## REAR BEARING OIL SEAL

An improved all composition crankshaft rear main bearing oil seal went into production, replacing the metal and composition oil seal, starting with engine 501484-A.

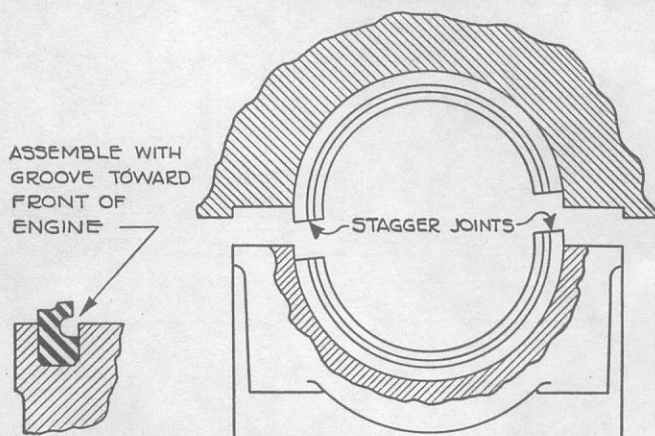
The new seal is interchangeable with the old and should be installed in engines previous to this number when trouble is experienced with oil leakage at the rear main bearing. Only the new oil seal piece 354629 will be supplied by the Service Stores Division. This piece number covers only one half of the seal and two will be required to make an installation.

When installing the new oil seal place the grooved face toward the front of the engine and let one end of the upper half extend into the bearing cap about one-quarter inch so as to stagger the joints in the seal in relation to the joints in the bearing and cap. Be very careful to see that the stagger of the seal is exactly the same in the upper and lower half. If it is not it will cause the seal to bulge and bind the crankshaft.

When the seal is seated the groove in the forward face is partially covered as shown in the illustration at the top. The upper half seal may be seated by placing a jack under the crankshaft and forcing it up into place.
